Access Compliance Report

Public Rights-of-Way

(Curb Ramps)

Intersection ID: 28614	Main Street: KESTRAL_RIDGE_DR	Cross Street: WARBLER_WOOD_CT	Location: SE
ADA ID: 0F4DDA816C55	Ramp Type: PerpDiag	Initial Pass/Fail: Pass	Overall Compliance: No
Severity Score: 22.5			
Codes/Mitigation Info/Possible Solution		Field Measurements/Component Compliance

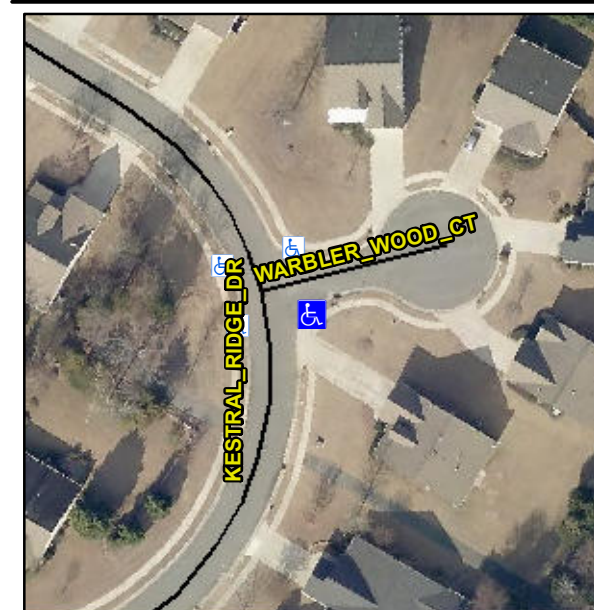
Not Found, R304.2.1, R305.1.4, R302.7.2, R304.5.4

Remove & Replace Curb Ramp With Two New Directional Ramps or Equivalent. Remove & Replace Gutter.
